FIELD OBSERVATION REPORT

Central Hardin High School – Phase 2, 2019111 -CA8

Report No: 31

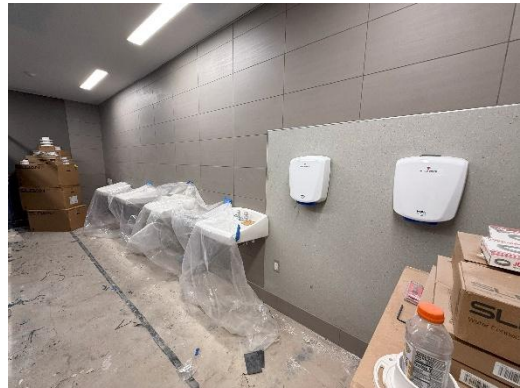
- a) The windows and door were installed in the connector.

The canopy was installed over the doors to the mechanical room.

- b) Although the connector will not be turned over to the school, work was progressing in this area.

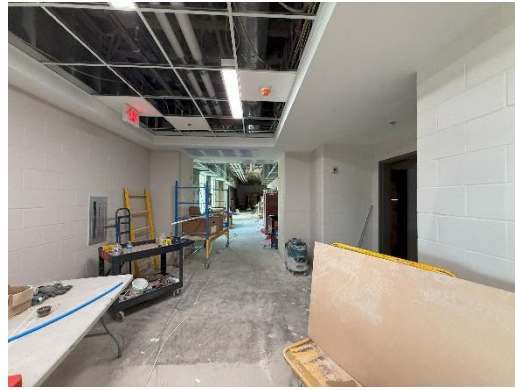
- f) The corridors appeared to be nearing completion.

Some touch-ups will be required for paint on the walls, but for the most part the walls appeared to be uniform.

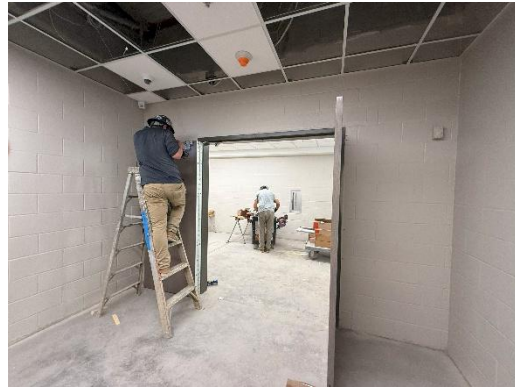
- q) Urinals and water closets were not installed.

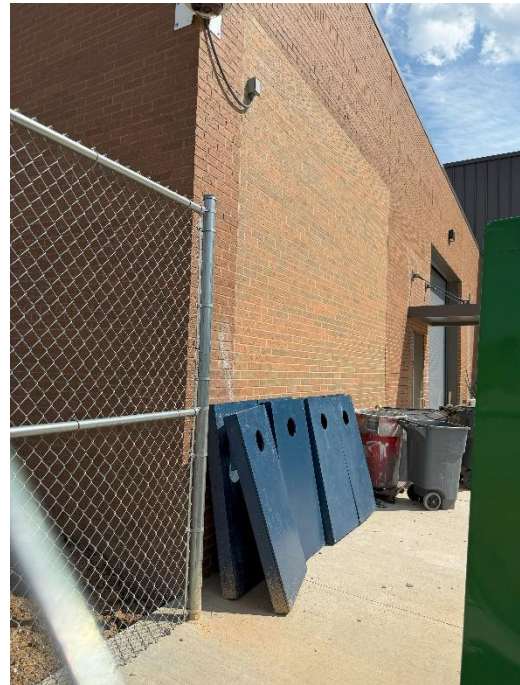
- u) Gill and I reviewed the LVT plank direction in Phase 1. The LVT was laid from east to west and extended into the rooms. This pattern will be used in Phase 2.
